AMENDMENT OF SOLICITATION

1. AMENDMENT/MODIFICATION NO. <p style="text-align: center;">0001</p>		2. EFFECTIVE DATE <p style="text-align: center;">MAR 16, 2004</p>	
3. ISSUED BY DEPARTMENT OF THE ARMY, BALTIMORE DISTRICT CORPS OF ENGINEERS P.O. BOX 1715 BALTIMORE, MARYLAND 21203-1715 CODE: _____

6. ACCOUNTING AND APPROPRIATION DATA (If required) MAINTENANCE DREDGING, WICOMICO RIVER, WICOMICO AND SOMERSET COUNTIES, MARYLAND			
7. DESCRIPTION OF AMENDMENT/MODIFICATION (Organized by UCF section headings, including solicitation/contract subject matter where feasible.) <u>SOLICITATION:</u> (1) <u>Section 00010, Unit Price Schedule:</u> Delete the Unit Price Schedule, as originally issued, and substitute therefor the attached revised Unit Price Schedule, dated MAR 15, 2004. <u>SPECIFICATIONS:</u> (2) <u>Index of Special Clauses and Technical Provisions, Page TOC-2, Attachments:</u> At the end of item 4, add: "04-WQ-003". (3) <u>Index of Special Clauses and Technical Provisions, Page TOC-2, Attachments:</u> Add the following to the list of attachments: "7. Mt. Vernon Placement Site - Pipeline Right Of Way Map" (4) <u>Section 1, Page 1, Paragraph 1, Lines 8 and 9:</u> Change "February 15"

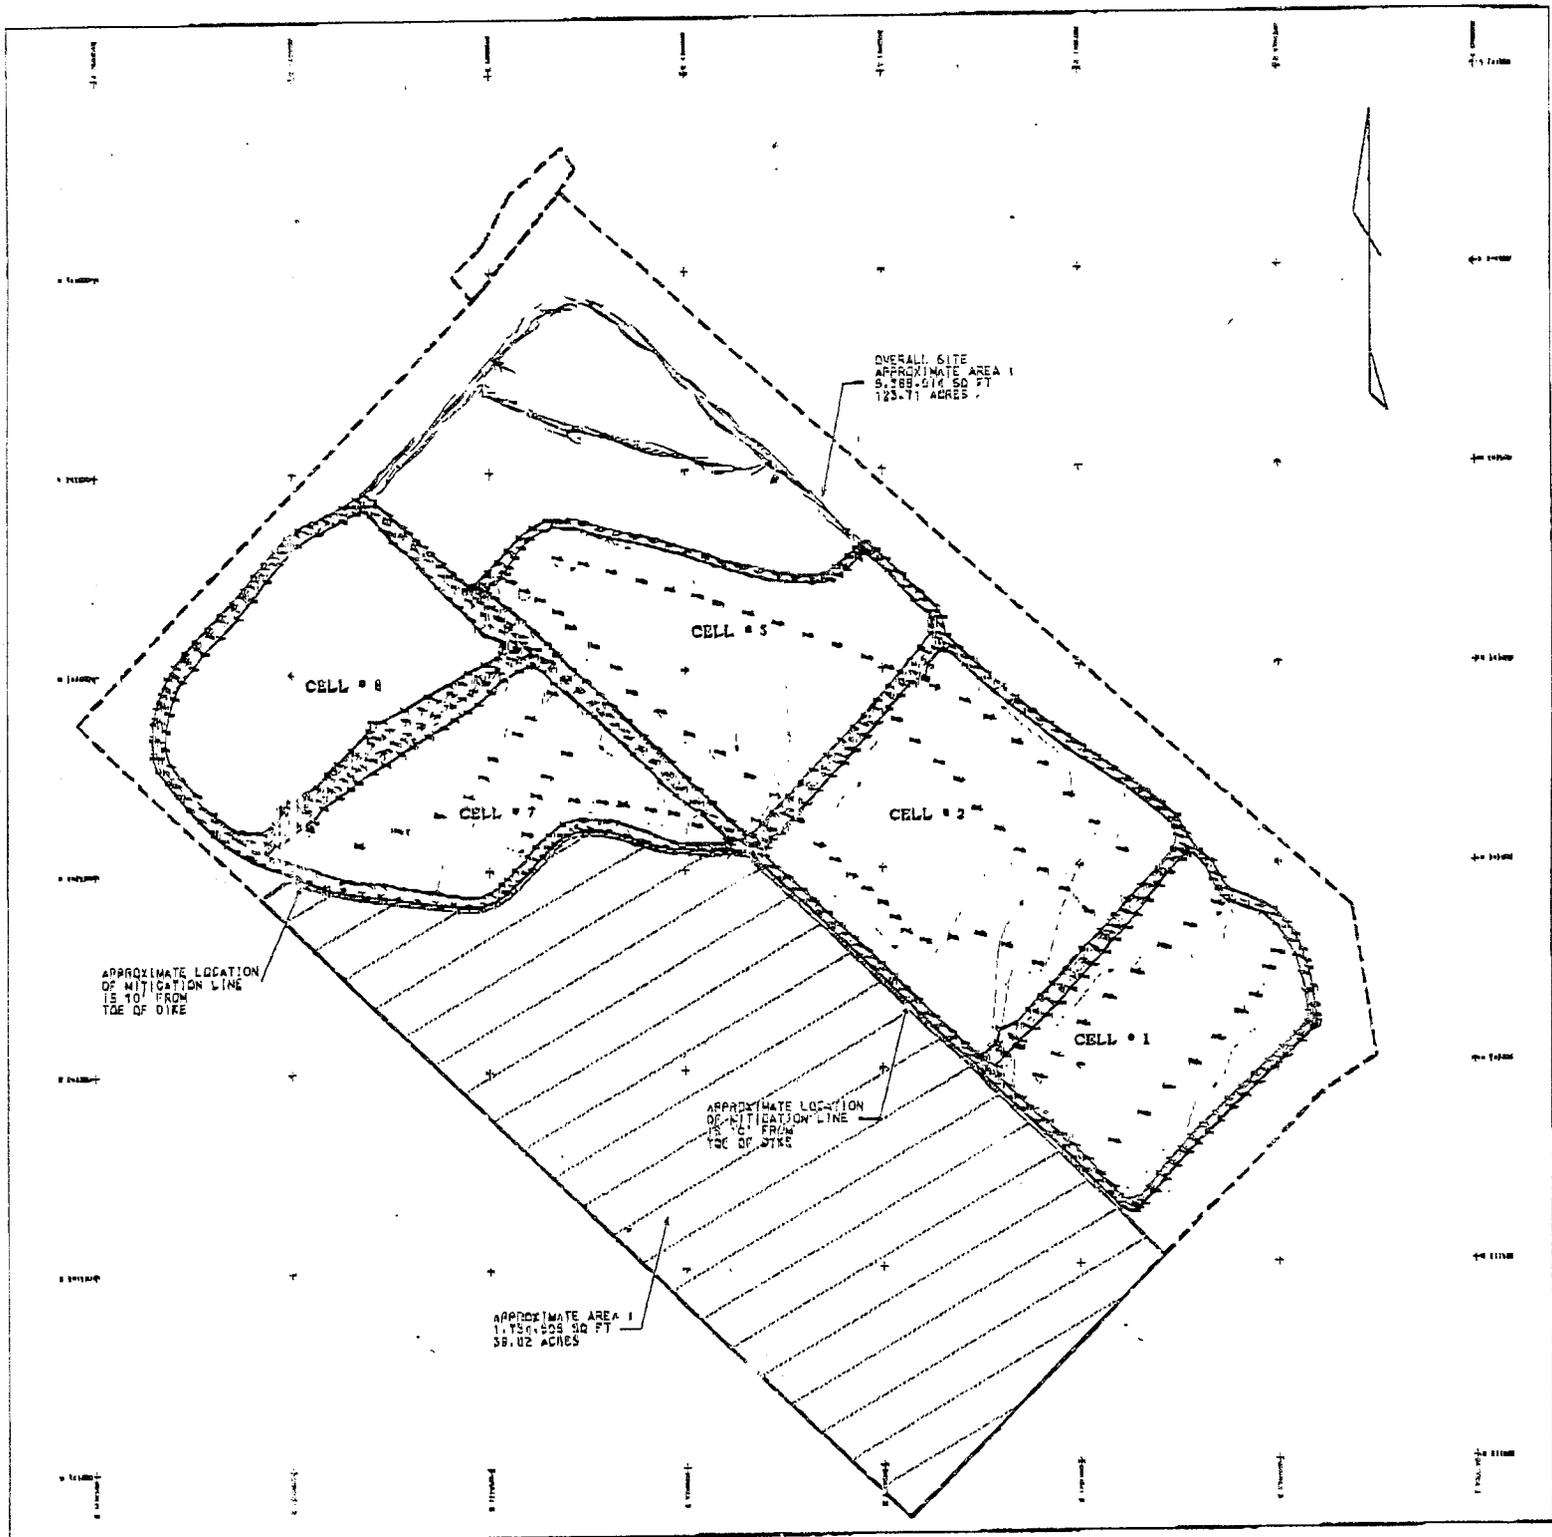
(X) (21) Disposal at the Sharps Point disposal site shall be undertaken in accordance with the attached diagram. There shall be no disposal in the hatched area of this diagram.

MT. VERNON PLACEMENT SITE - PIPELINE RIGHT-OF-WAY MAP

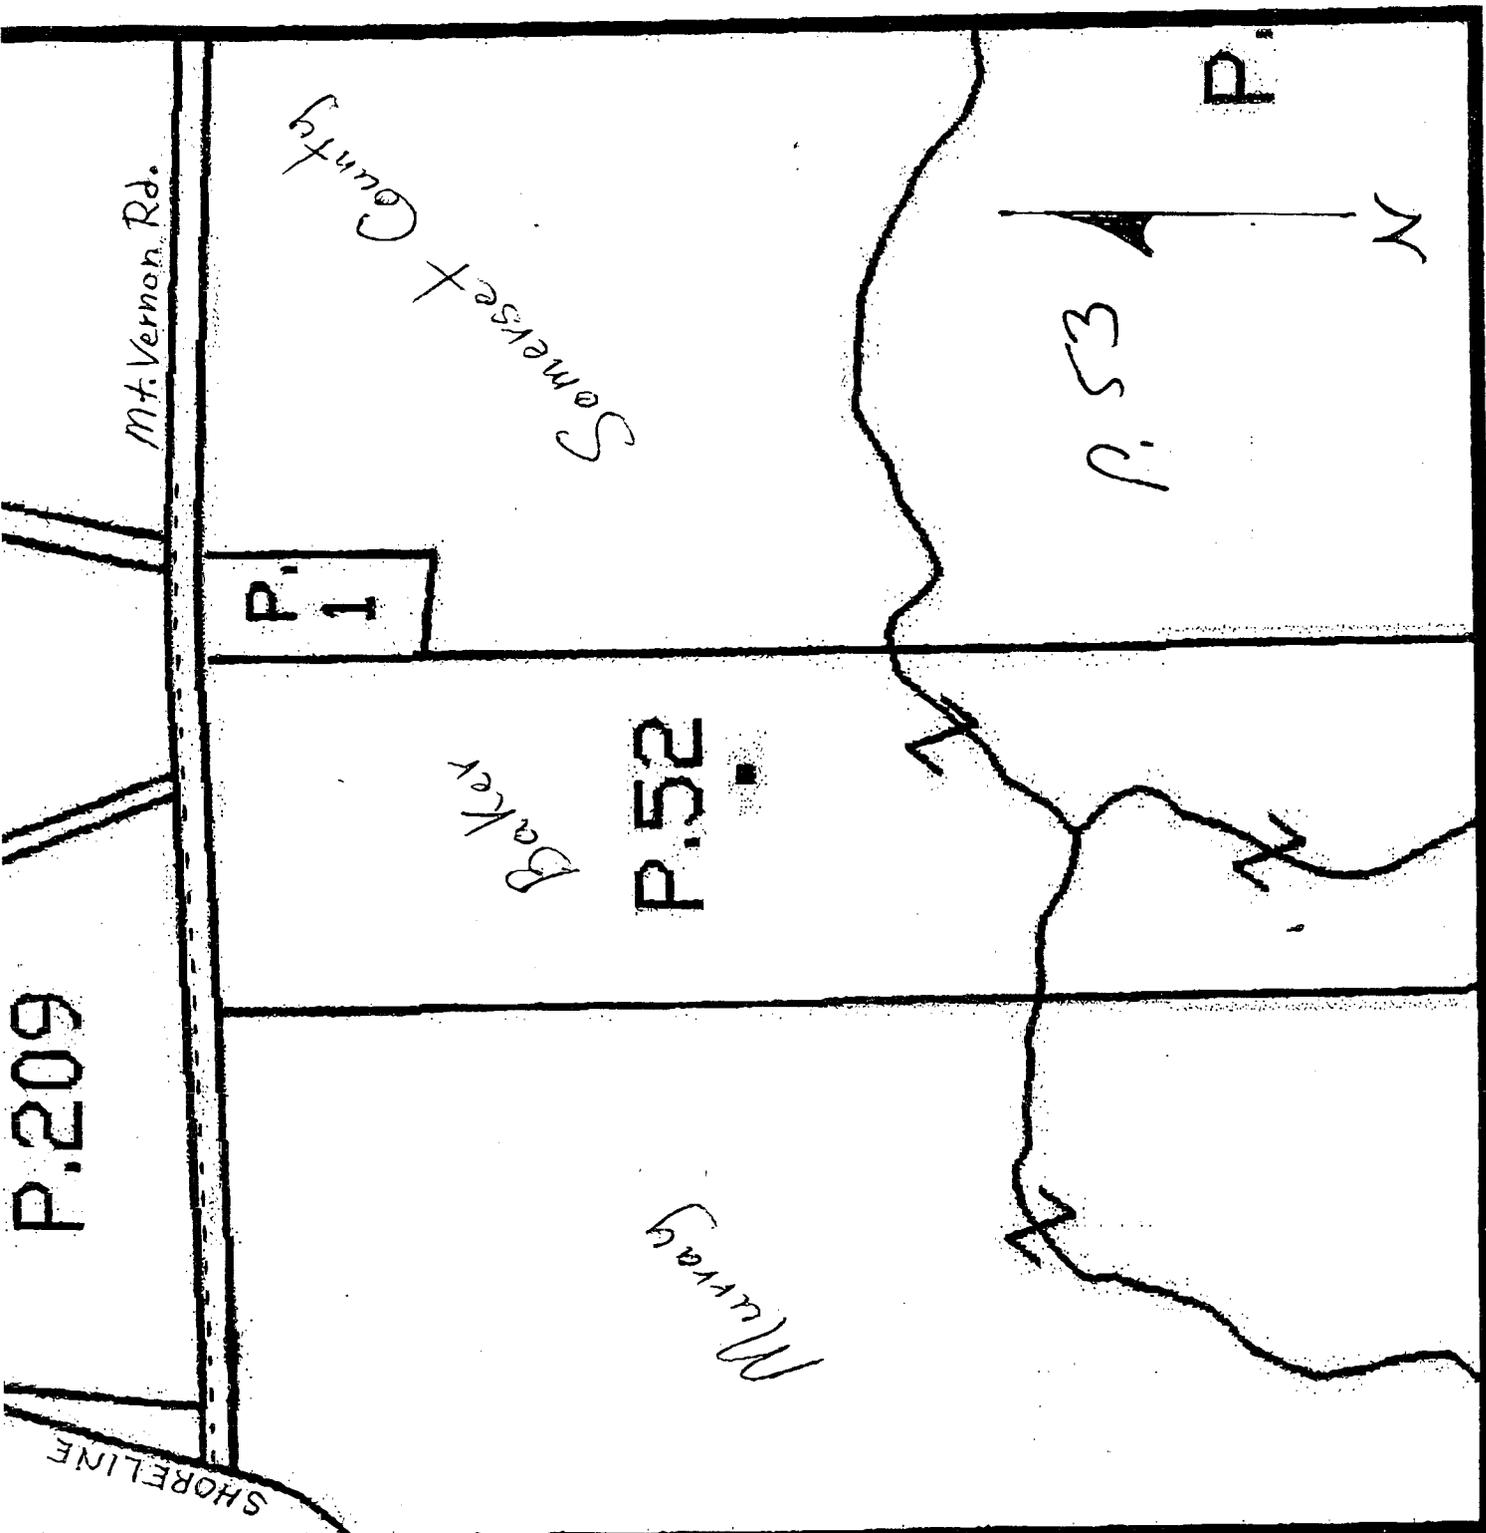
----- indicates proposed placement of drudge pipe along the north side of Mt. Vernon Road, within the Somerset County right of way.

"8. Pipeline Right of Ways: The Sharp's Point placement site pipeline right-of-way where shown on the placement site drawings is Government furnished. The Mt. Vernon placement site pipeline right-of-way where shown on the "MT. VERNON PLACEMENT SITE - PIPELINE RIGHT OF WAY MAP", located at the end of these specifications, is Government furnished. The pipeline must be weighted down and submerged at all times in and around the area of the docks, to prevent interference with boats. However, the Contractor is not restricted to the right-of-ways shown on the contract drawing(s). In those cases where the Contractor routes a pipeline outside of the Government furnished right-of-way or disposal area property, he shall obtain all easements, permits, and right-of-ways at his own expense."
